Project response to communication from K. Bowling 12/10/04

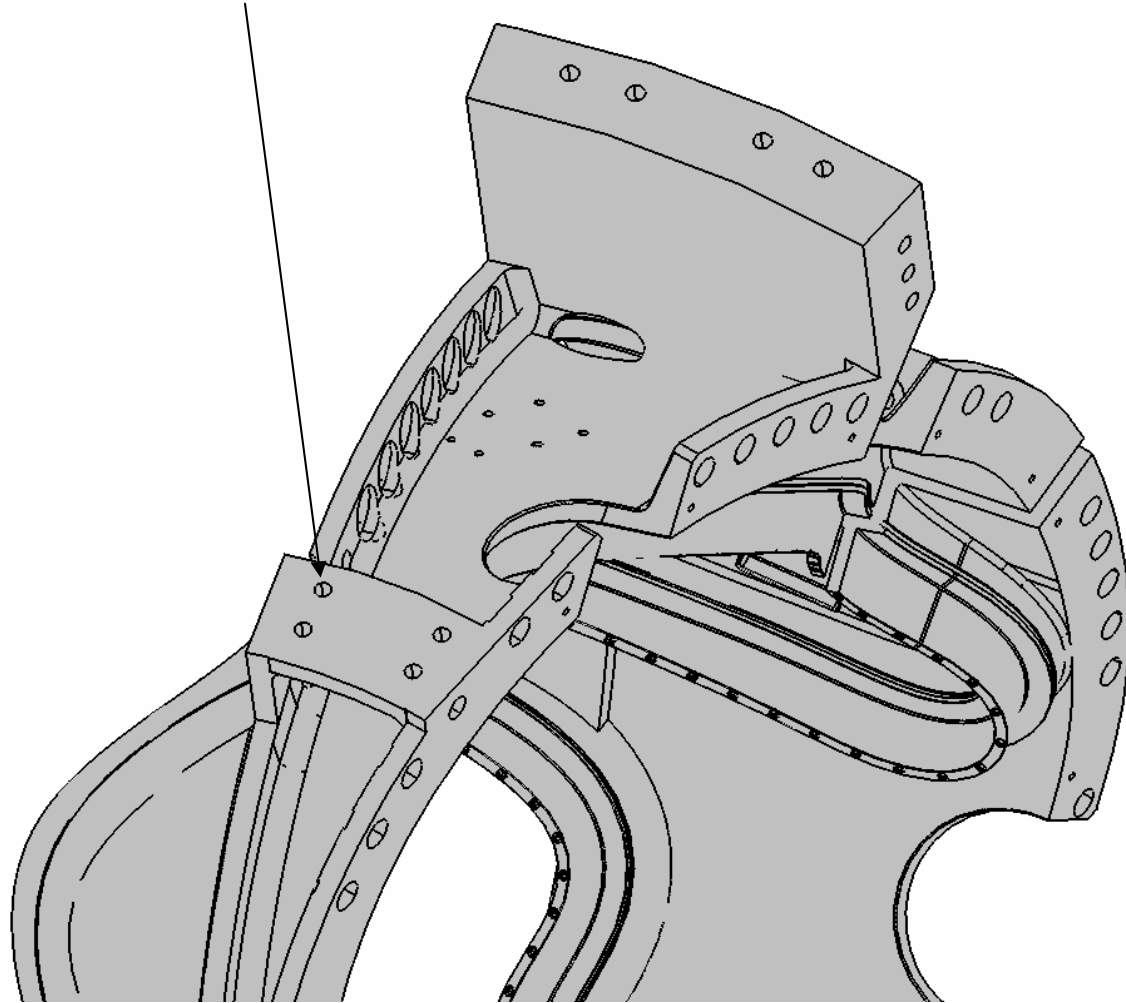
Item	A	B	C	Sheet/ Zone	Drawing	CAD Model	Status	Project Response
	Count	Count	Count					
2	16	8	3		Ø.875 TAP DRILL	Ø1.0	OK Ref tap drill Ø	Drawing is correct. Model hole size will be changed to 0.875-in diameter.
	"	"	"		1-8 TAP

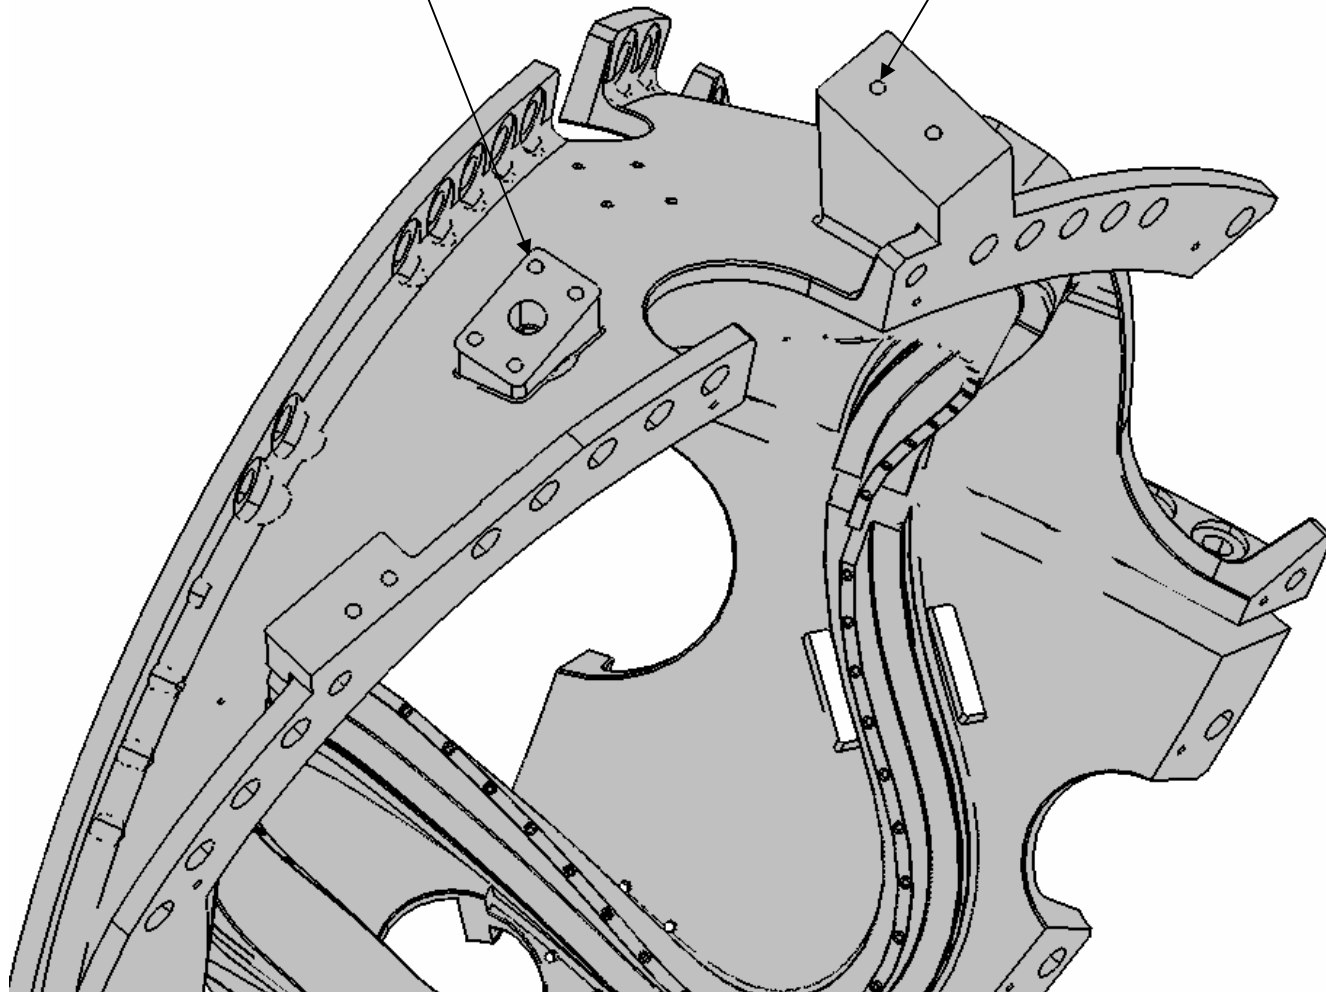
Item	A	B	C	Sheet/ Zone	Drawing	CAD Model	Status	Project Response
		Count	Count					
3		8		3 C5	Ø.875 TAP DRILL	Ø.766	open	Drawing is correct. Model hole size will be changed to 0.875-in diameter.
		"		"	1-8 TAP			
4		8		3 C6	Ø.875 TAP DRILL	Ø.755	open	Drawing is correct. Model hole size will be changed to 0.875-in diameter.
		"		"	1-8 TAP

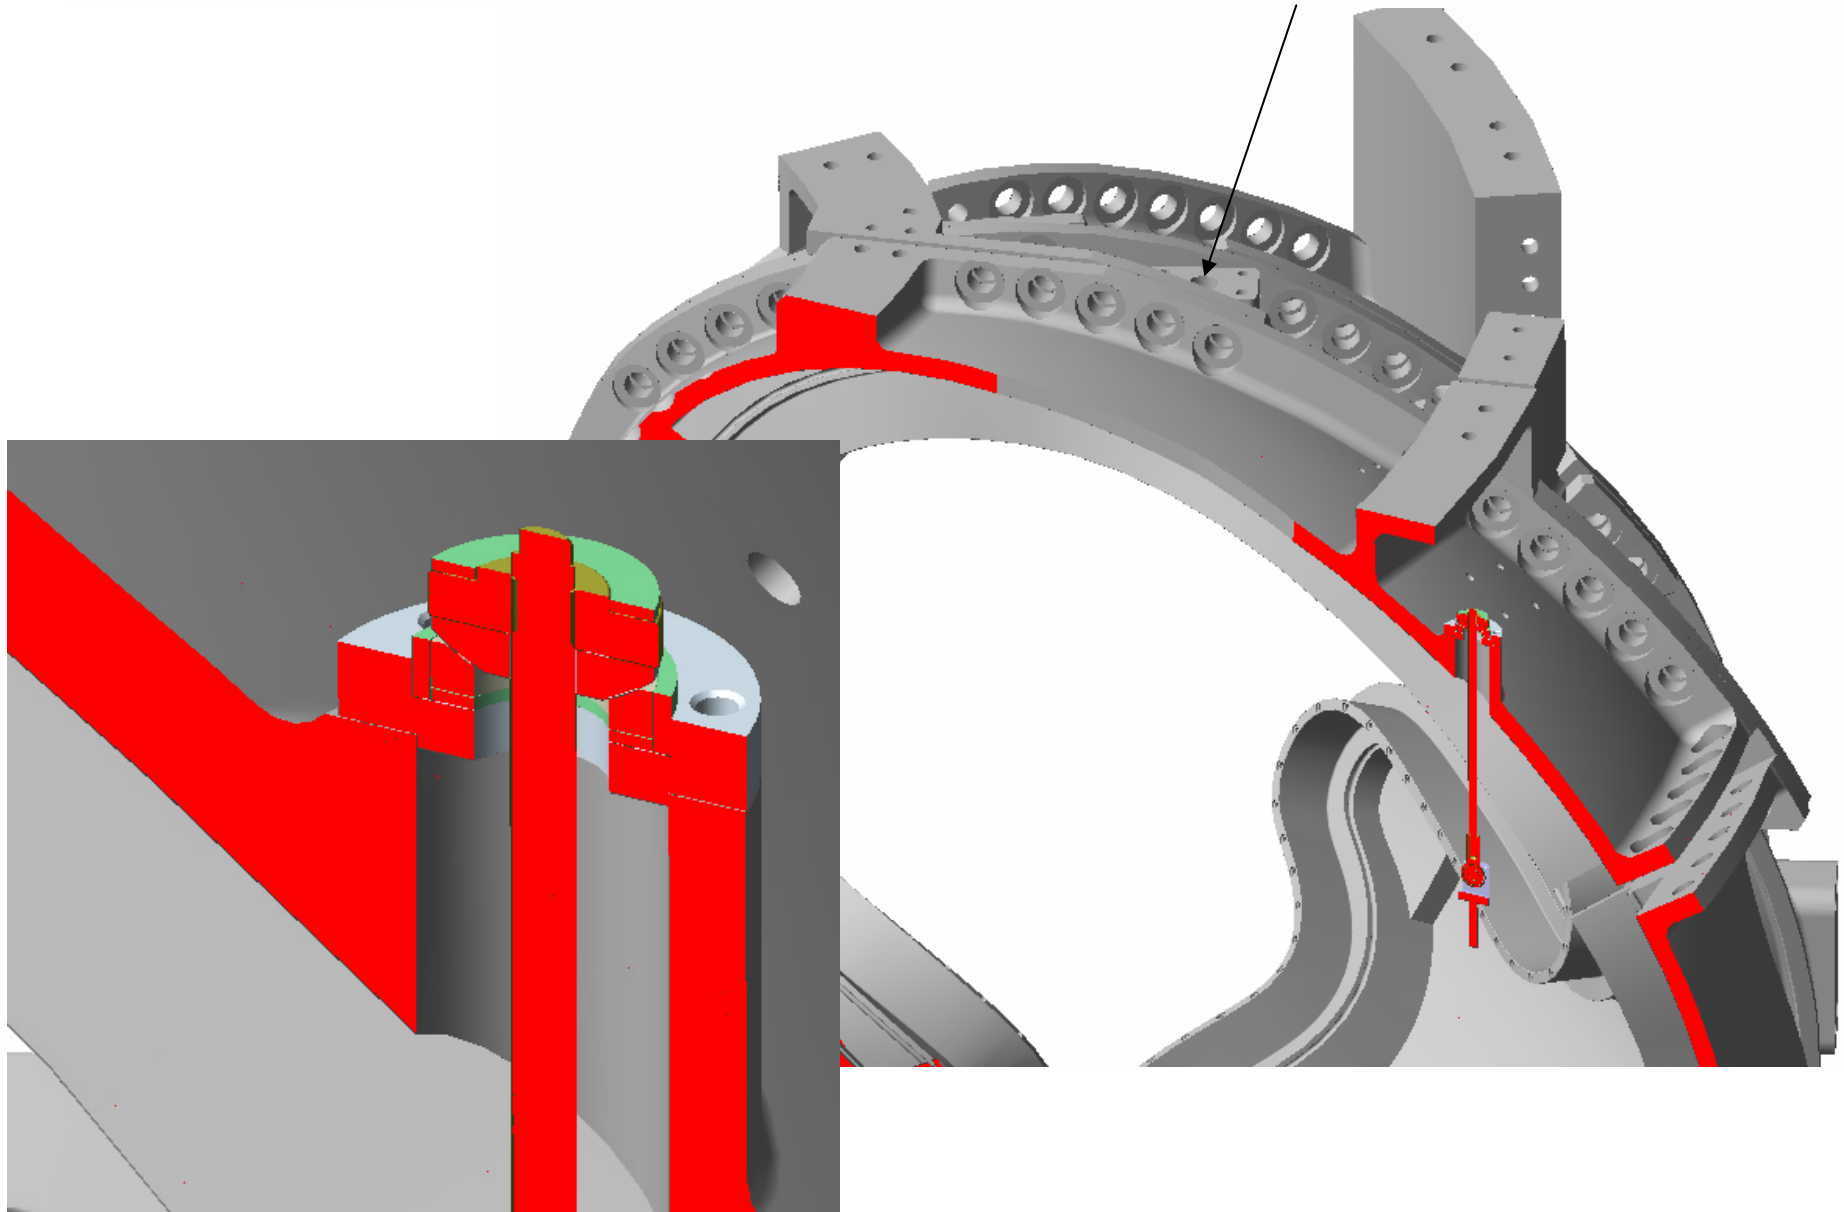
Item	A	B	C	Sheet/ Zone	Drawing	CAD Model	Status	Project Response
		Count	Count	Count				
5		2		3 F2	Ø1.48 X 5 Thru (5.0 DP)	Ø1.5	open	Change to 2.5-in dia thru, like Drw -114, Sht3, D2. Tapped holes next revision.
		"		"	Ø1.86 X 2.5 DP CBORE	Ø1.875	open

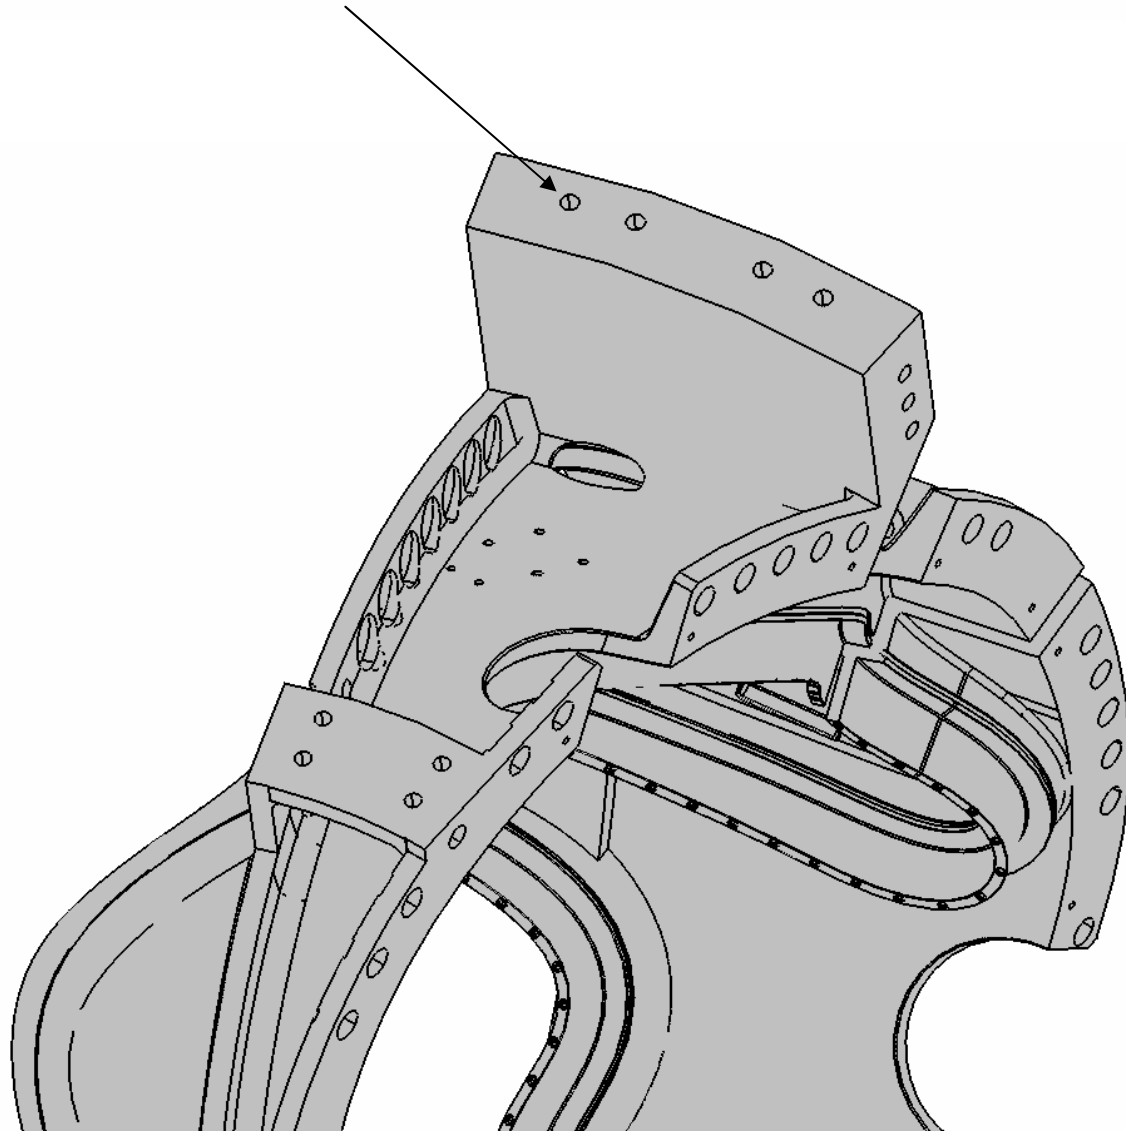
Item	A	B	C	Sheet/ Zone	Drawing	CAD Model	Status	Project Response
	Count	Count	Count					
6			8	3	Ø1.125			Drawing callout is correct.
			"	"	Ø3.0 BACK SPOT FACE	not in model	open

FLANGE INTERFACE A-A (symmetry about midplane)

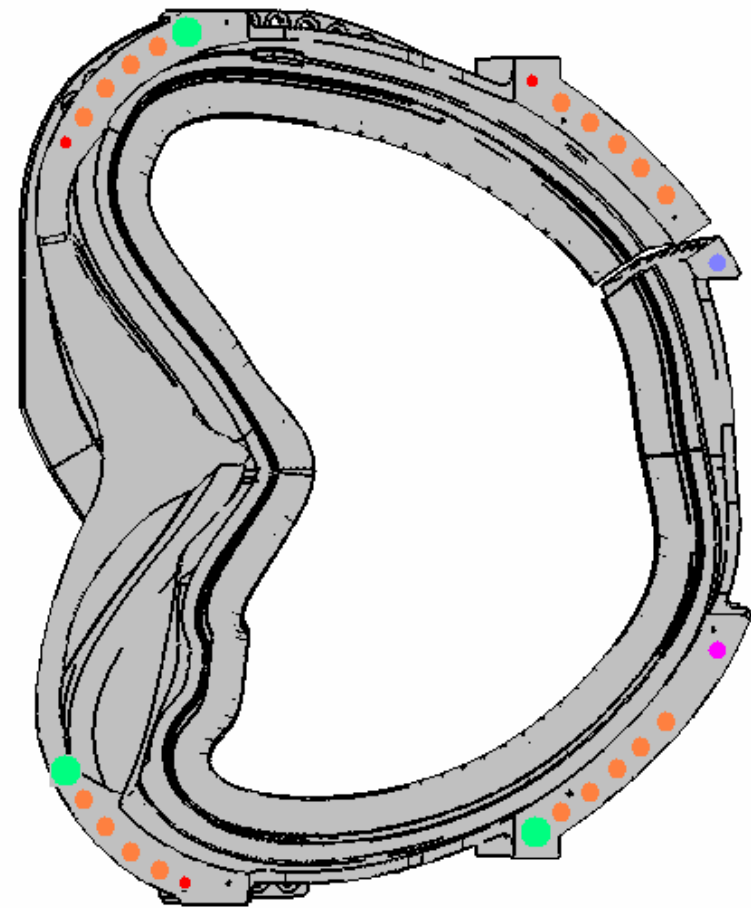
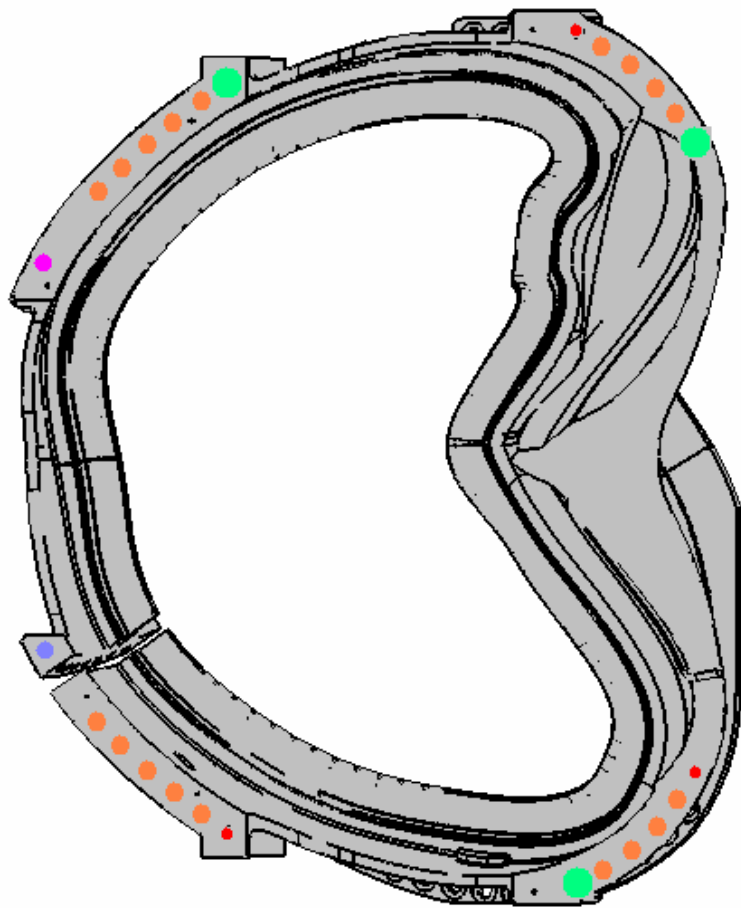
- ↔ ● $\phi 1.875$ DRILL, $\phi 3.25$ BACK SPOT FACE > SAME
- ↔ ● $\phi 1.375$ -6UNC THRU > $\phi 1.875$ DRILL, $\phi 3.0$ BACK SPOT FACE
- ↔ ● $\phi 3.0 \times 1$ DP CBORE, $\phi 1.5 \times 1.5$ DP / THRU > SPHERICAL .75R

7	18	24	17	4	Ø1.875 DRILL			Sheet 4 - See Figures 6-9 for flange-to-flange hole template. Drawing notes to be clarified, models will be revised to match figures.
	"	"	"	"	Ø3.25 BACK SPOT FACE		2X type C 7.75 long	
	1	1	4	4	Ø1.875 DRILL			
	"	"	"	4 E4	Ø3.0 BACK SPOT FACE	Ø3.25	open	
	3			4	Ø.75 Thru (1.375 DP)	Ø1.50	open	
	3			4	Ø3 x 1 DP CBORE			
	6	10	20	4	Ø.201 x .5 DP			
	"	"	"	"	.250-20 TAP	no tap on A	open	
	"	"	"	"	Ø.507 x 82 Deg Chamfer			
8	1	3	4	5	Ø1.875 DRILL	check C5 Sec ZZ		Sheet 5 - See Figures 6-9 for flange-to-flange hole template. Drawing notes to be clarified, models will be revised to match figures.
	"	"	"	5 D7	Ø3.0 BACK SPOT FACE	Ø3.25	open	
	3	3	2	5	Ø3 x 1 DP CBORE			
	3		2	5	Ø.75 x 2.33-B/ 2.0-C	Ø1.50	open	
			3	5	Ø1.5 X 1 DP			
	3			5	Ø1.5 X 1.33 DP			
				5	Ø1.125 DRILL			
				"	Ø3.38 BACK SPOT FACE	Ø2.38	open	
		7			Ø1.500 DRILL	Ø1.625	open	
9	3	3	3	7 C4	nothing	Ø.435 x .5 DP	is this correct?	Tapped holes (3X) for terminal block mount can be omitted.

SE141-115, SHT 4

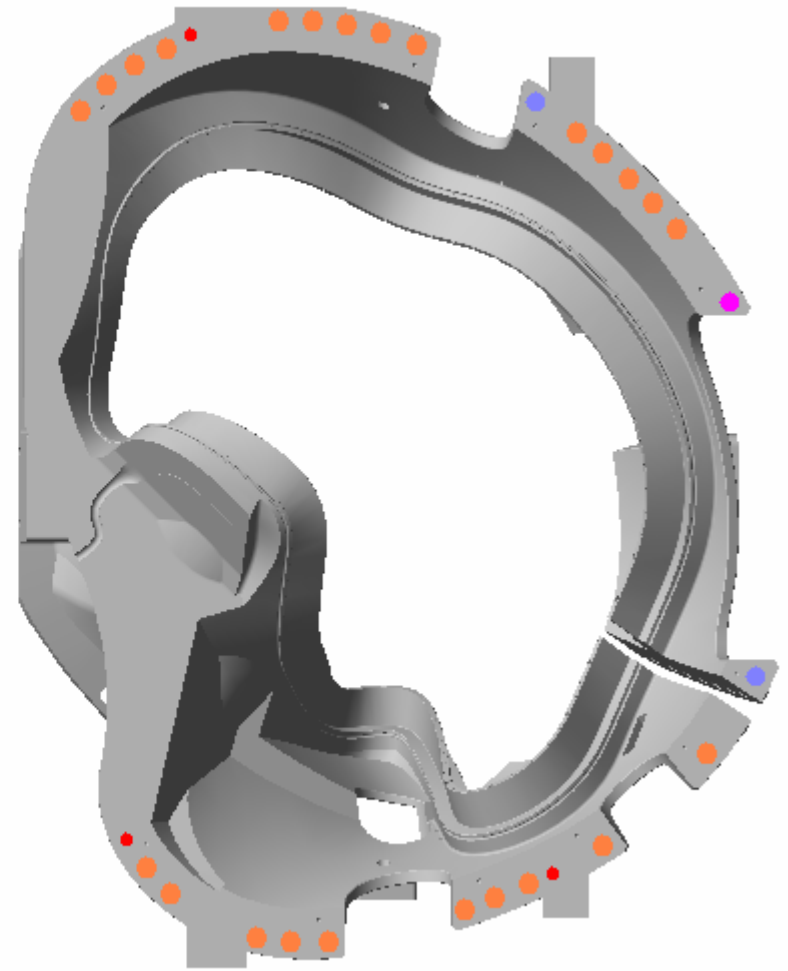
- ↔ ● $\phi 1.875$ DRILL, $\phi 3.25$ BACK SPOT FACE > SAME
- ↔ ● $\phi 1.375-6UNC$ THRU > $\phi 1.875$ DRILL, $\phi 3.0$ BACK SPOT FACE
- ↔ ● $\phi 3.0 \times 1$ DP CBORE, $\phi 1.5 \times 1.5$ DP / THRU > SPHERICAL .75R

SE141-116, SHT 4

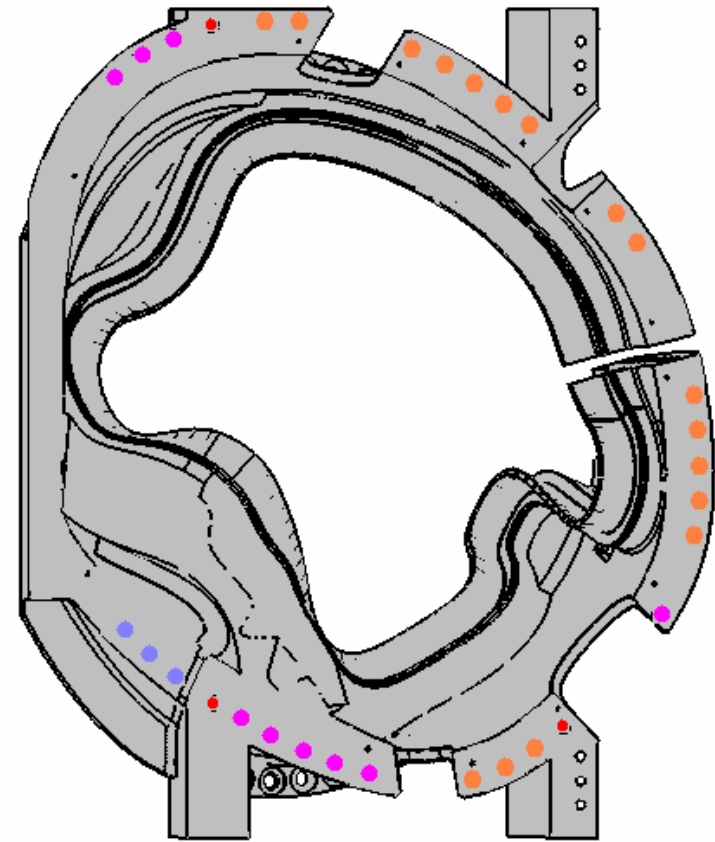
- ↔ ● $\phi 1.875$ DRILL, $\phi 3.25$ BACK SPOT FACE > SAME
- ↔ ● $\phi 1.375$ -6UNC THRU > $\phi 1.875$ DRILL, $\phi 3.0$ BACK SPOT FACE
- ↔ ● $\phi 3.0 \times 1$ DP CBORE, $\phi 1.5 \times 1.5$ DP / THRU > SPHERICAL .75R

FLANGE INTERFACE C-C (symmetry about midplane)

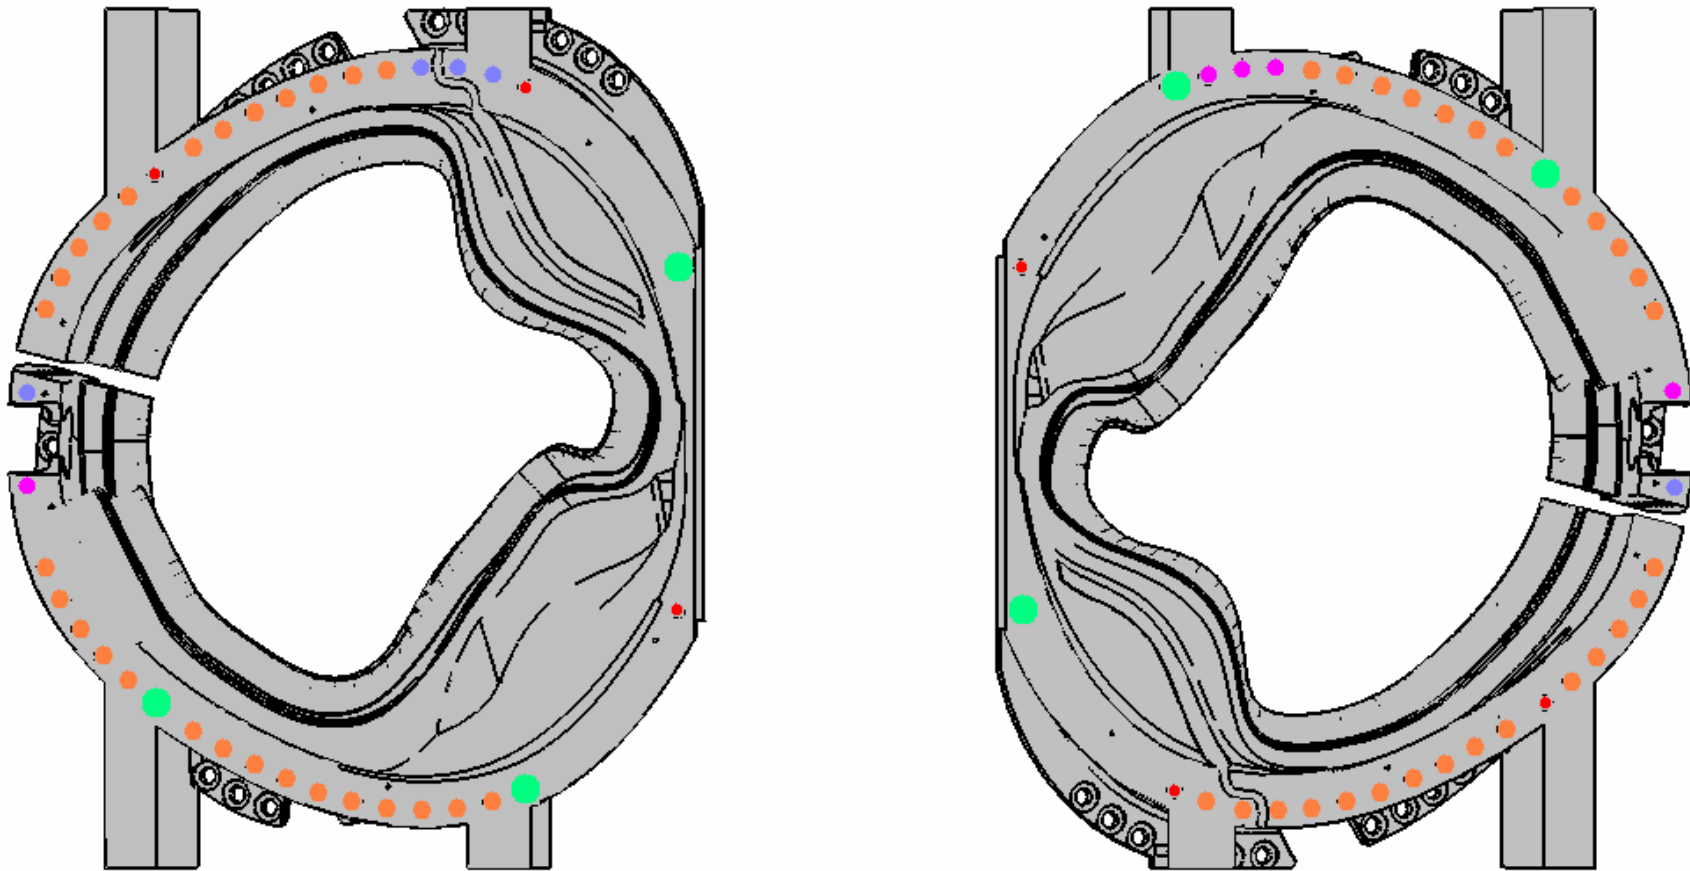
- ↔ ● $\phi 1.875$ DRILL, $\phi 3.25$ BACK SPOT FACE > SAME
- ↔ ● $\phi 1.375$ -6UNC THRU > $\phi 1.875$ DRILL, $\phi 3.0$ BACK SPOT FACE
- ↔ ● $\phi 3.0 \times 1$ DP CBORE, $\phi 1.5 \times 1.5$ DP / THRU > SPHERICAL .75R
